SUNNICA ENERGY FARM

EN010106

**8.52 Update by the Applicant on Heritage Matters and Substation
Connection**

Version	Date	Status of Version
Rev 00	28 November 2022	Deadline 3A Submission

Appendix A Plan A: Crash Site Exclusion Area

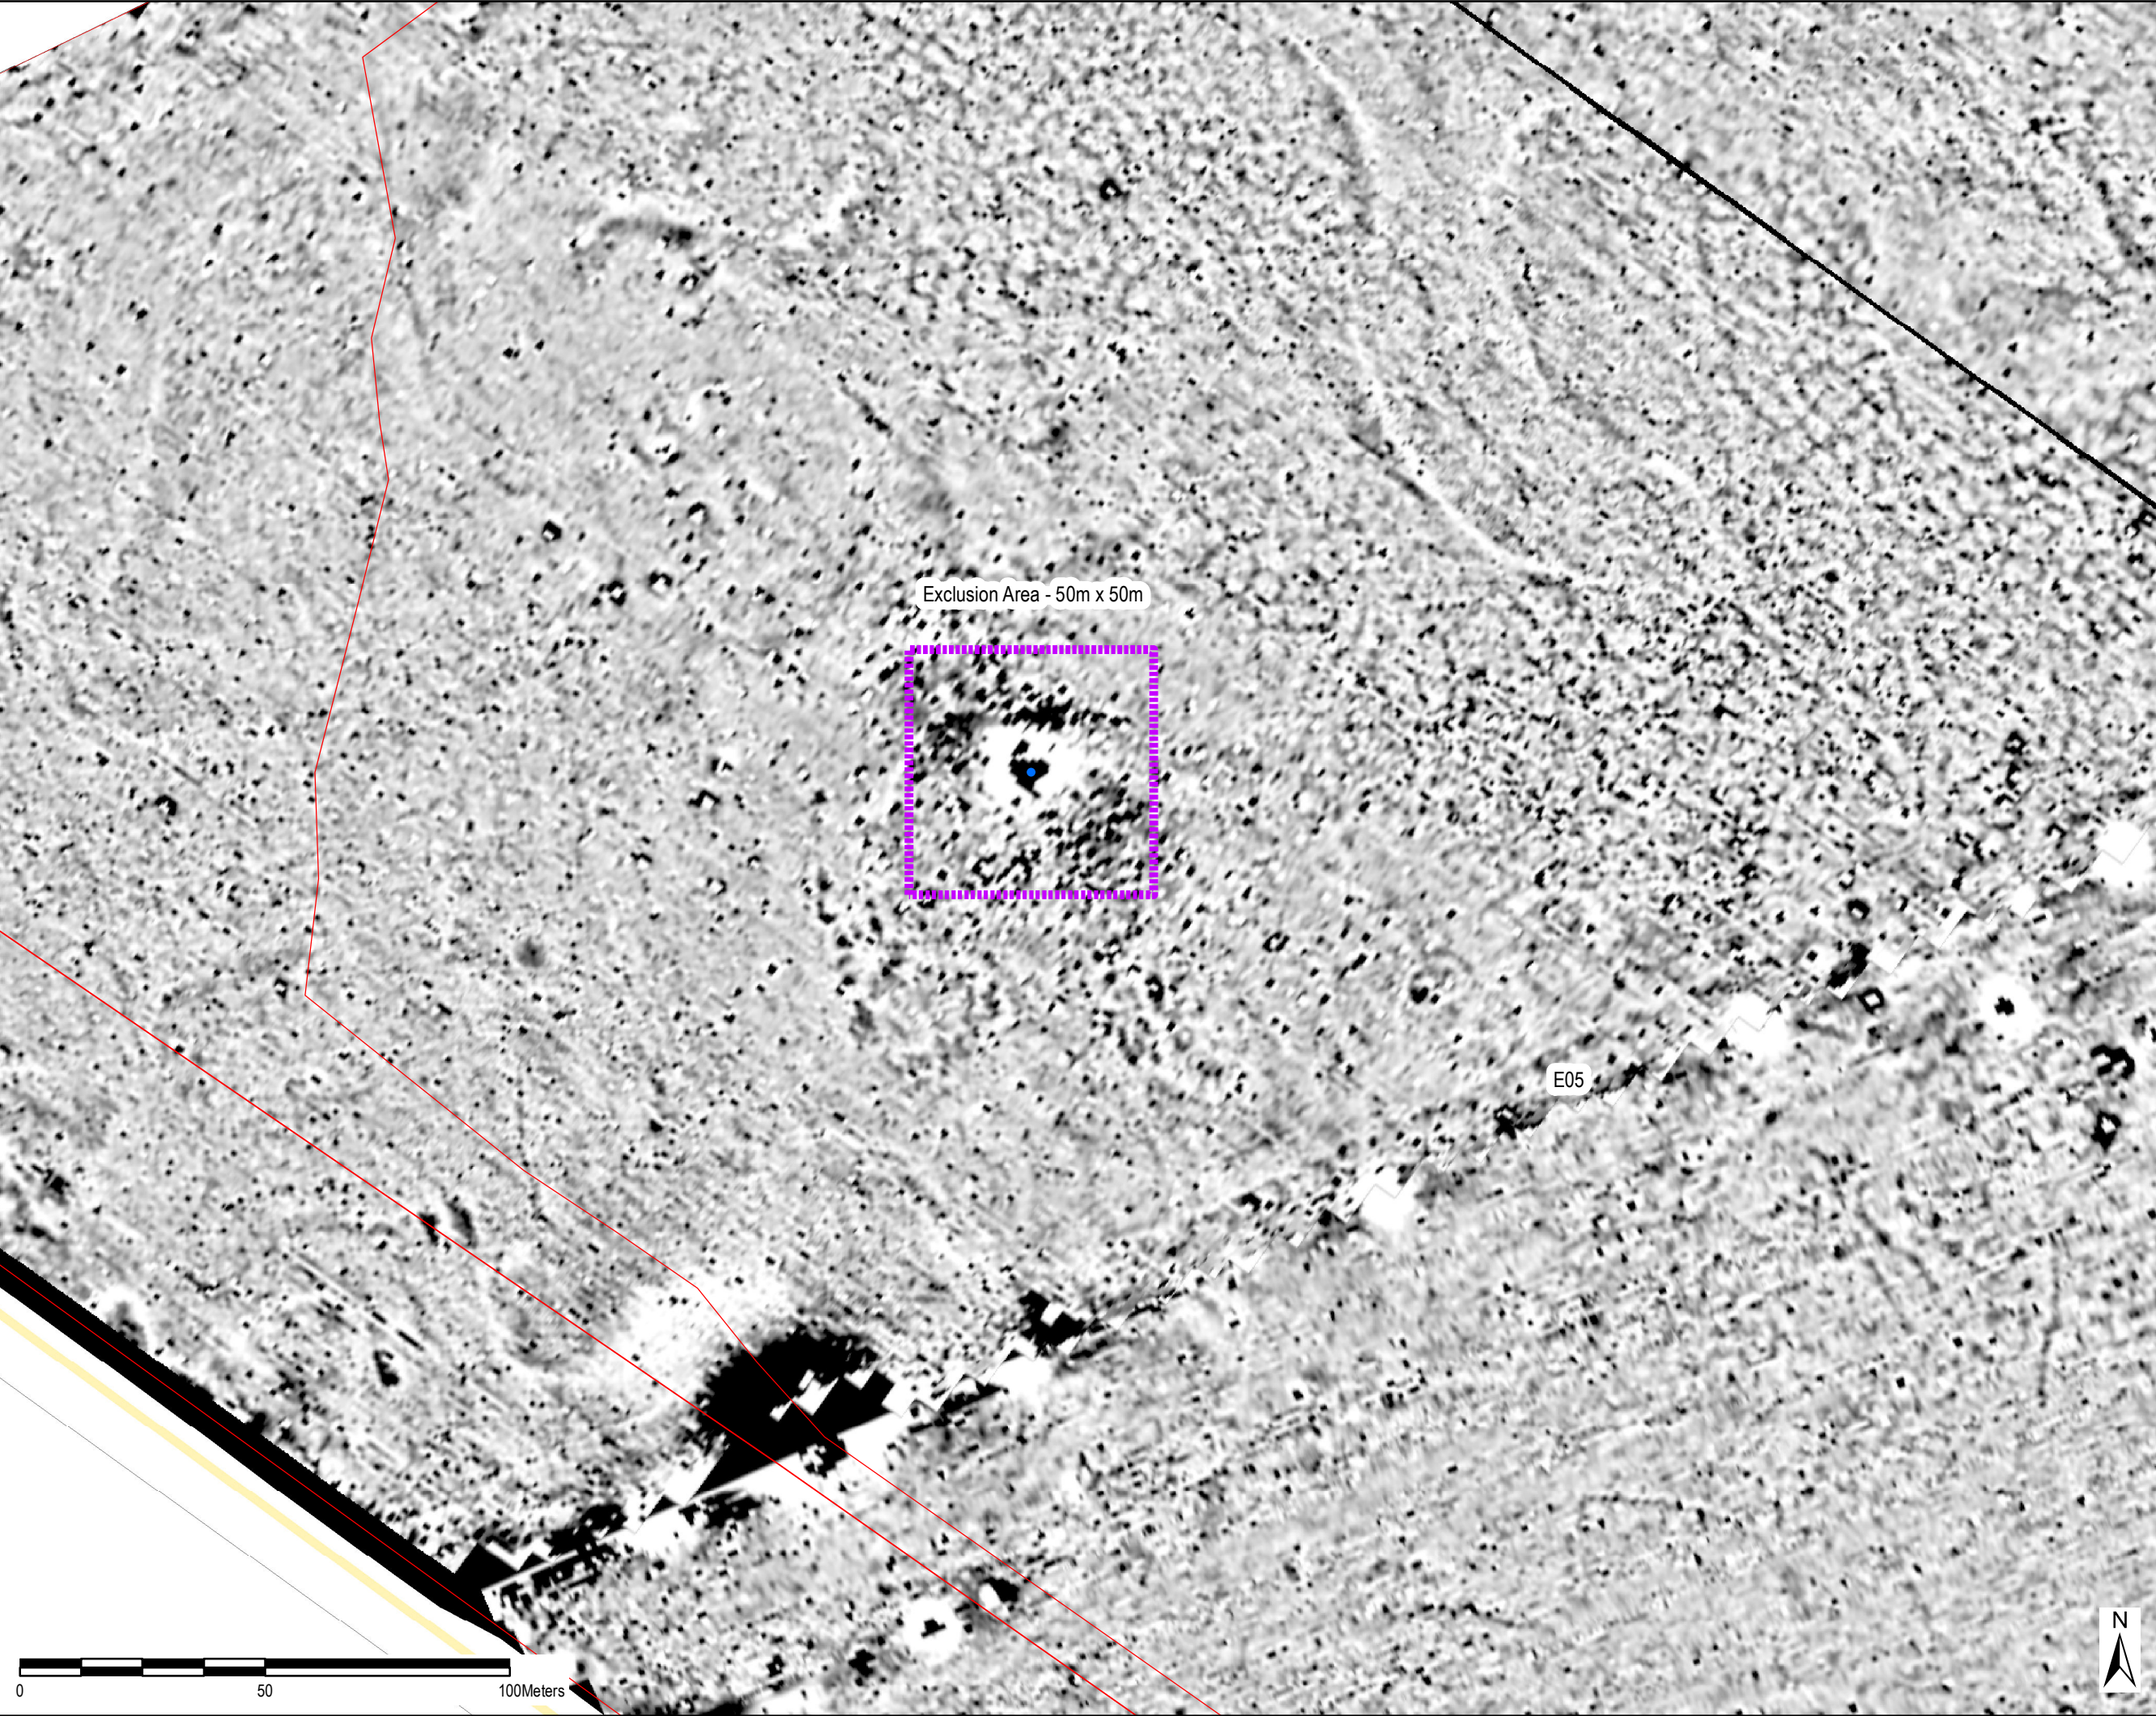
- 4.1.9 The Applicant agrees that the crash crater is an important location and the immediate area over the crater should be excluded from development. The exclusion zone over the crater would be to preserve a physical, though not visible, feature relating to the tragedy. The exclusion zone could also be subtly marked as part of the development design to be locatable when viewing from the proposed information board and commemorative plaque. Development of arrays around the exclusion zone will not impact the significance of the event or the location.

- 4.1.15 The 'crash site exclusion area' is the immediate area over the crater referred to in paragraph 4.1.9 which is excluded in all circumstances. That is shown on Plan A to this note, which will be certified by the DCO, and is a 50m box encompassing the area formed by the crash crater.

(1) No part of the authorised development may take place within the crash site exclusion area.

Appendix B Plan B: Potential Expanded Crash Site Exclusion Area

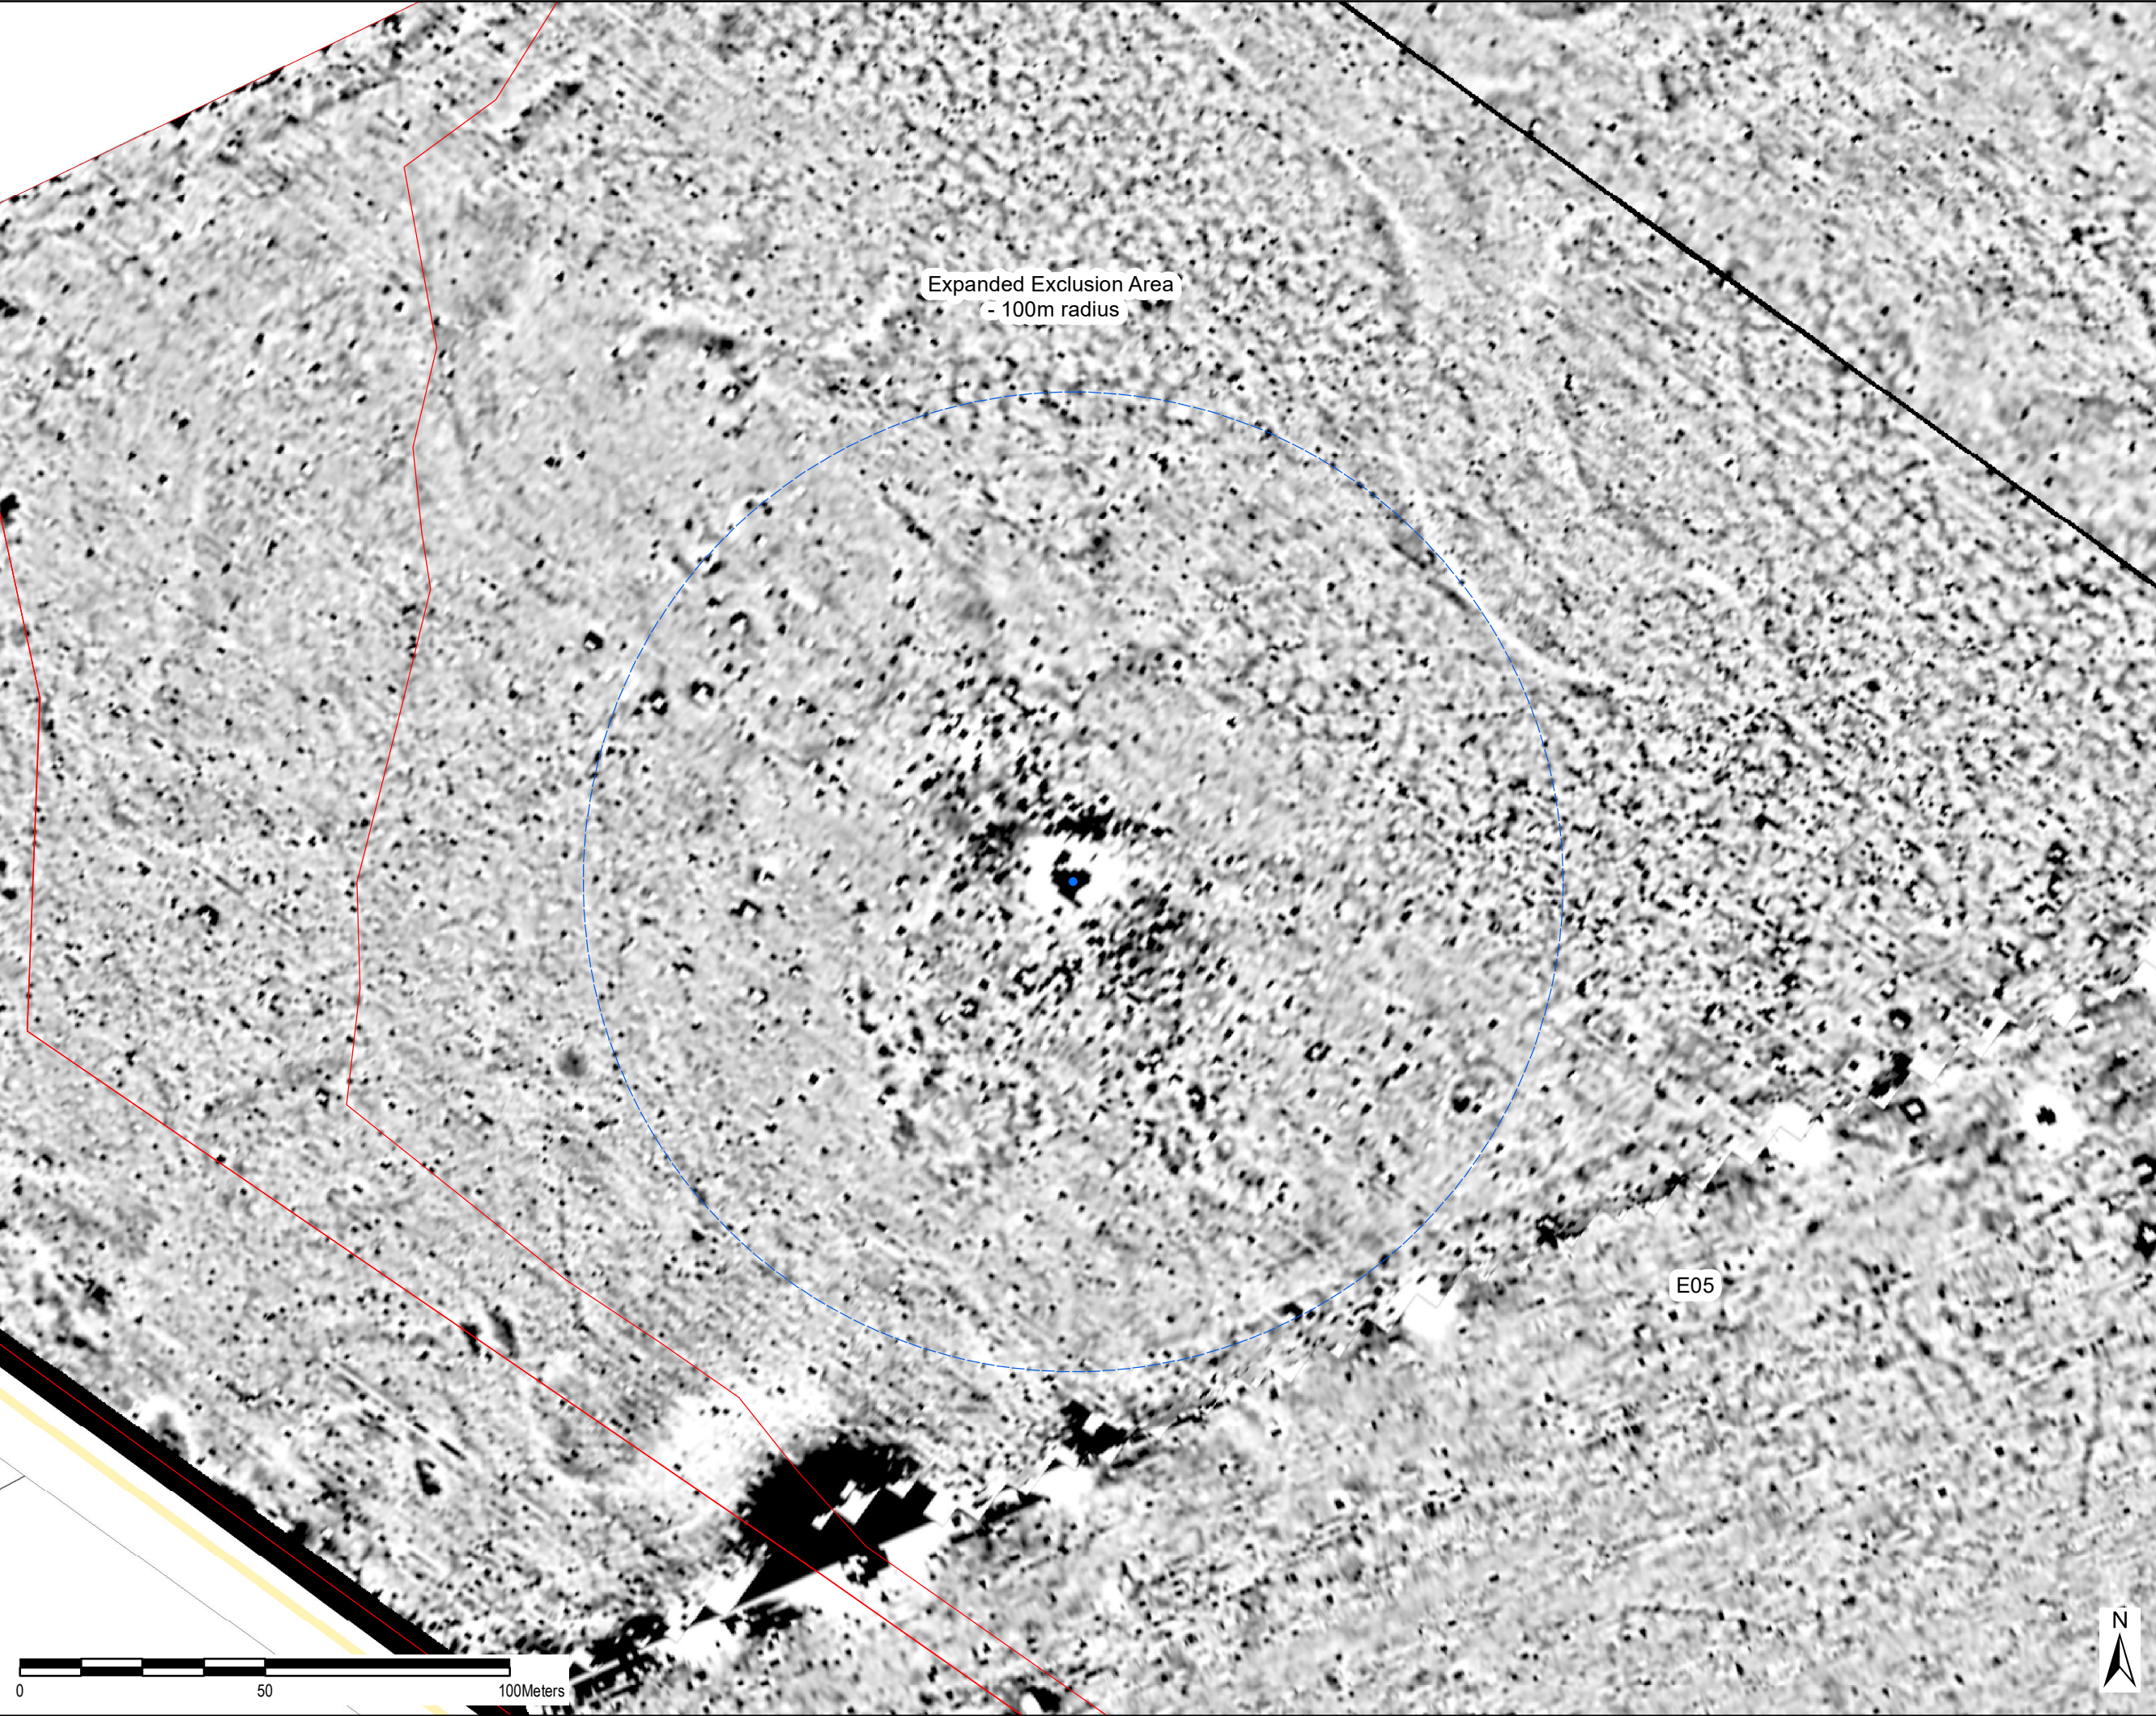
- 4.1.16 The 'potential expanded crash site exclusion area' referred to in that draft Requirement is the area set out in Plan B to this note. This area would be within a 100m radius from centre point of the crash site (the crater), which is an area consistent with the area that JCCC's licenses seek to protect.

- a. the power generation created by the Scheme would be reduced by the total of the area within the 100m radius from the centre point which is approximately 3.14 Ha. Therefore, an estimate of approximately 3.1MWp of installed capacity solar PV would be removed from the overall installed capacity of the Scheme.

(a) a licence under the Protection of Military Remains Act 1986 has been obtained in respect of the carrying out of Work No. 1A within the potential expanded crash site exclusion area; or

- e. *(b) a licence under the Protection of Military Remains Act 1986 has not been obtained in respect of the carrying out of Work No. 1A and that therefore no part of the authorised development will take place within the potential expanded crash site exclusion area.*

(3) If the undertaker makes a confirmation under sub-paragraph (b) then no part of the authorised development shall take place within the potential expanded crash site exclusion area.
